STANDARD FIELD SERVICE BULLETIN

FSB Number	CHRAEFSB2016-30 Rev. 1
Author	Tony Bryan
Date	10/31/2016
Subject	Moto Z Play, Moto Z Force Droid, Moto Z, Moto Z Droid - Fingerprint Reader
Model Affected	XT1650-01/02/03/04/05, XT1635-01/02/03
Level Of Repairs	Level 2

Figure 3.0 - Example of scanned output QR Code print

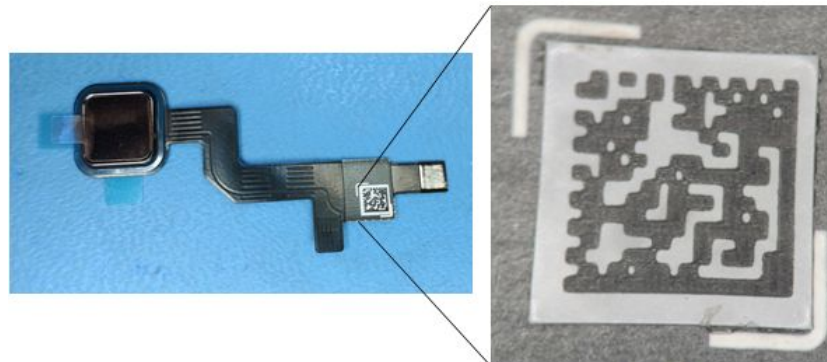
The affected supplier has optimized their ACF Bonding Process to help prevent this issue - Completed 8/24/2016. See Figure 3.0 below for how to decode the QR Code print and determine if part was produced after the supplier improvements.

Good Date Code = 8/24/16
 QR Code Output: 168R (YYMD)
